UNITED STATES ENVIRONMENTAL PROTECTION AGENCY

Re: Comments on the Sherwin-Williams August 16, 2004, Remedial Investigation Work Plan Implementation Sequence (Implementation Strategy); Gibbsboro, NJ

Comments on the August, 2004 Remedial Investigation Work Plan Implementation Sequence (Implementation Strategy)

5-1

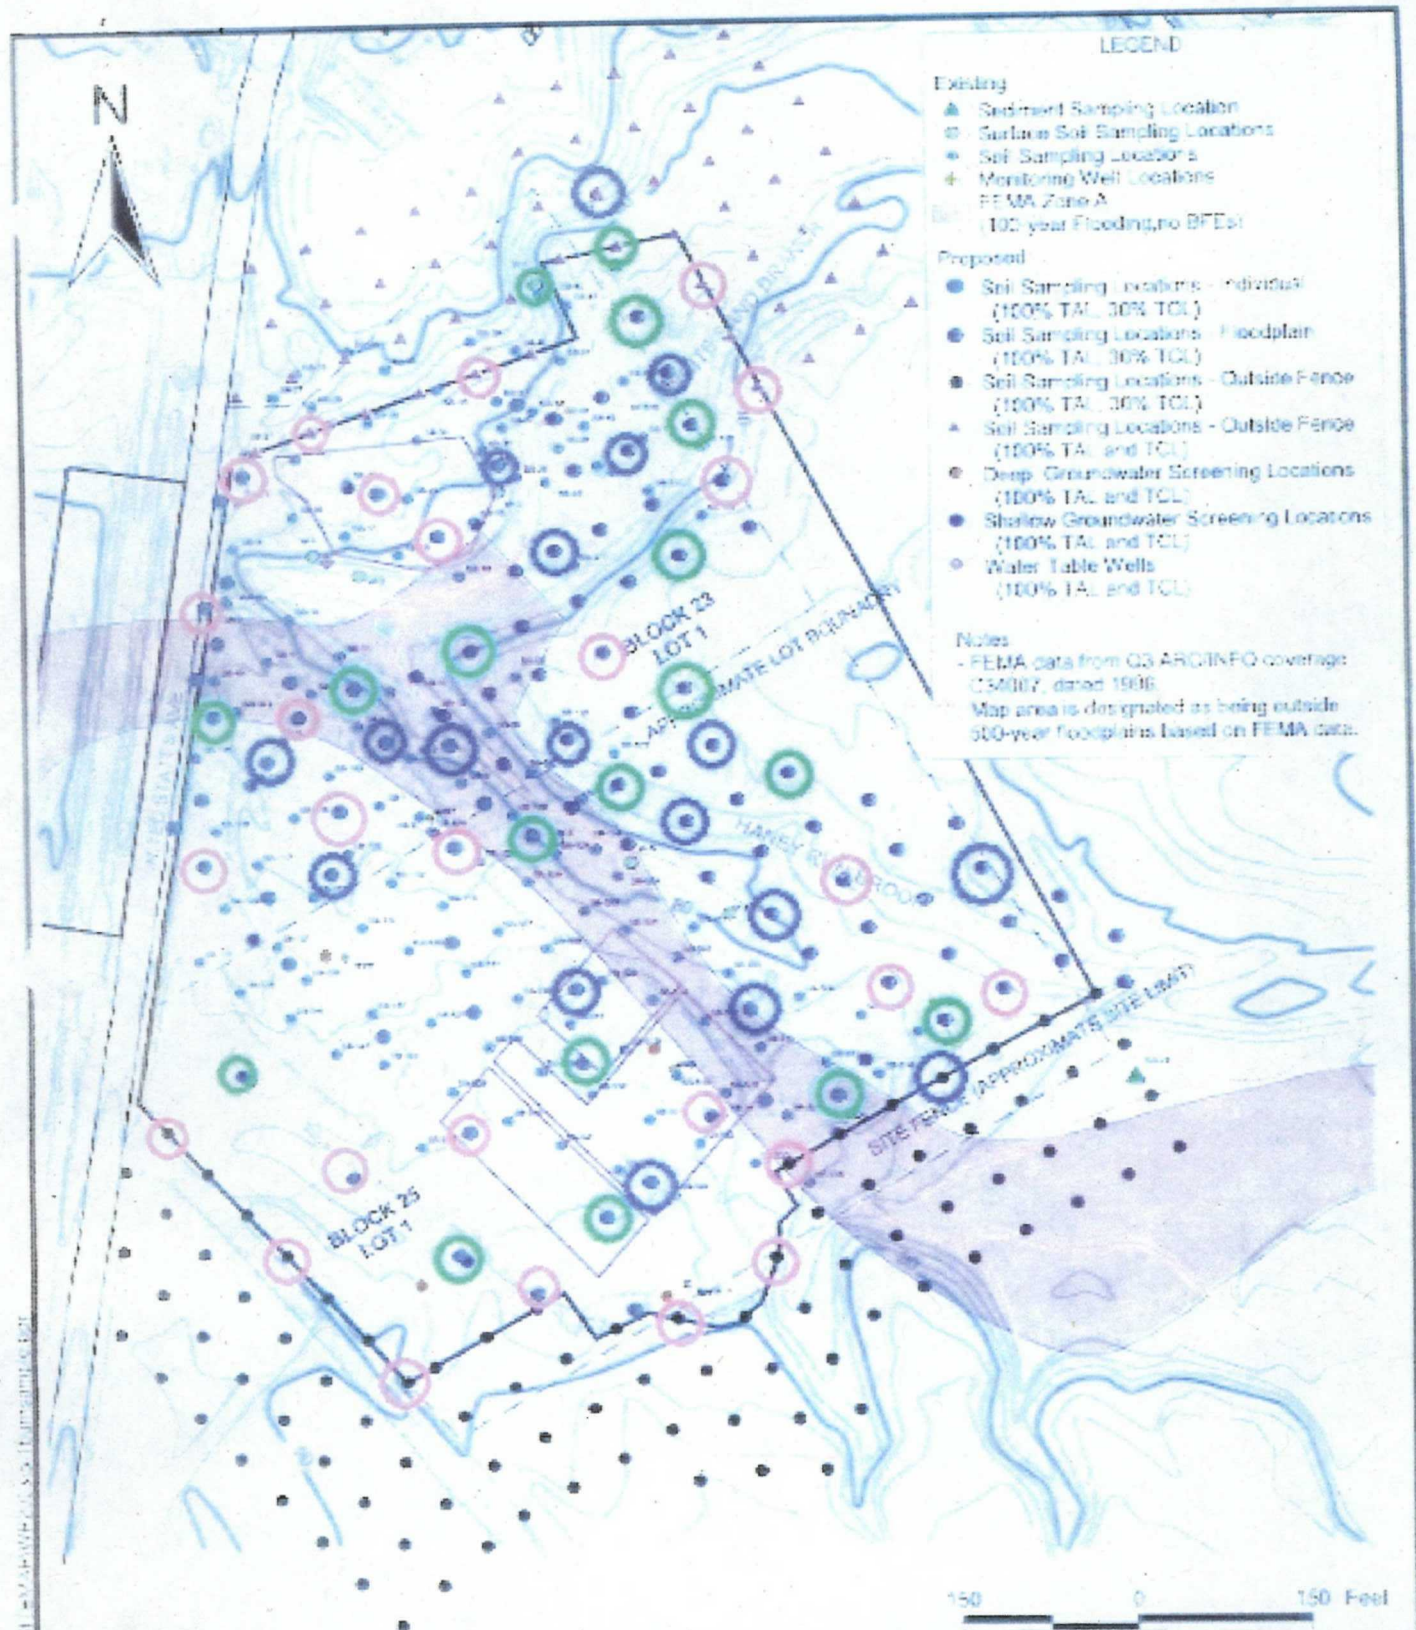
EPA has used the following color scheme for figures 5-1, 5-2, and 5-9 to translate our comments on the strategic sampling locations submitted by Sherwin-Williams:

Red = sample locations agreed upon by both EPA and Sherwin-Williams

Blue = sample locations recommended by EPA

Green = sample locations recommended by Sherwin-Williams

FIGURE #:
 5-9

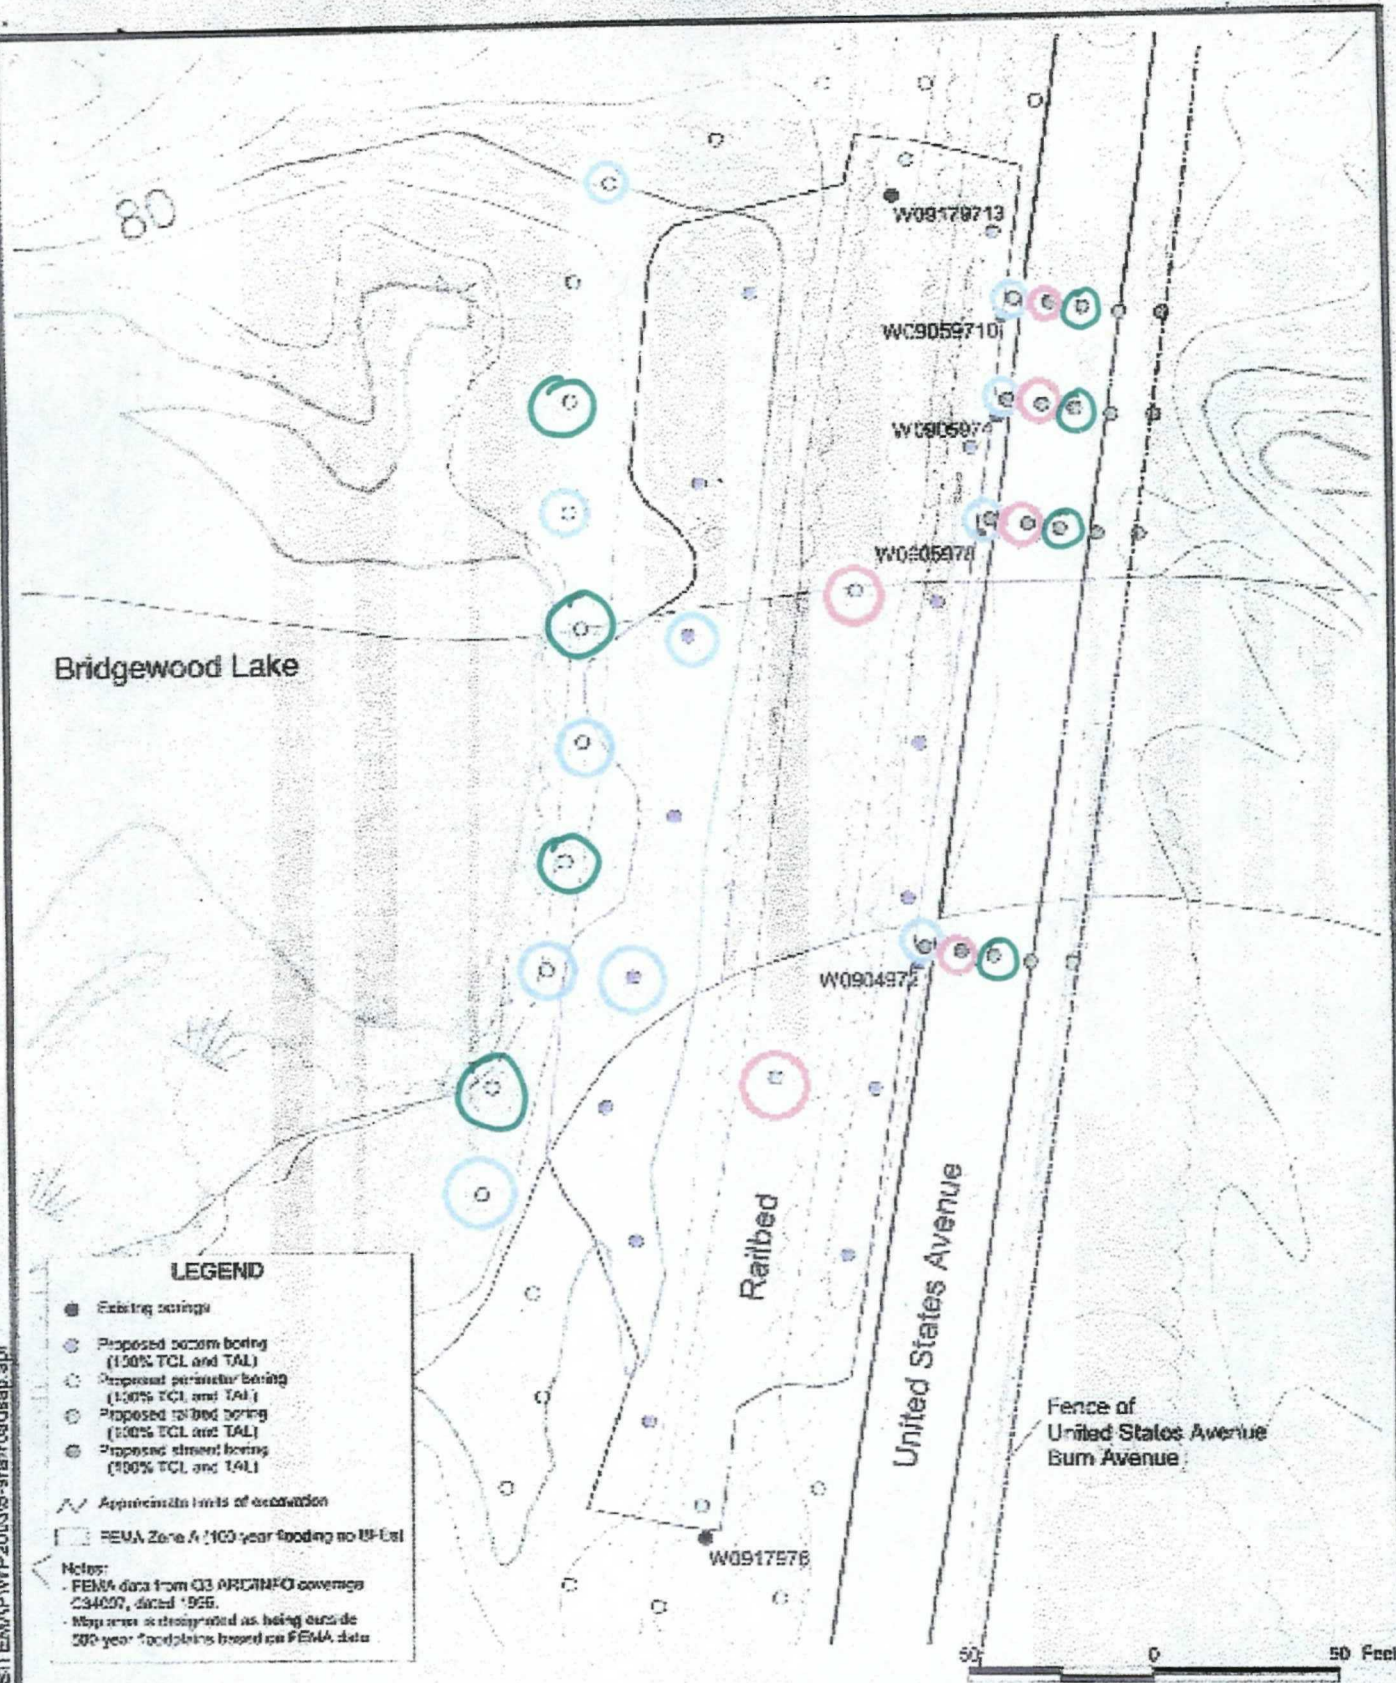
Note: only at the Railroad Site has EPA recommended an increase in the total number of samples previously suggested by Sherwin-Williams. The initial total suggested by Sherwin-Williams was 14, EPA is proposing 17.
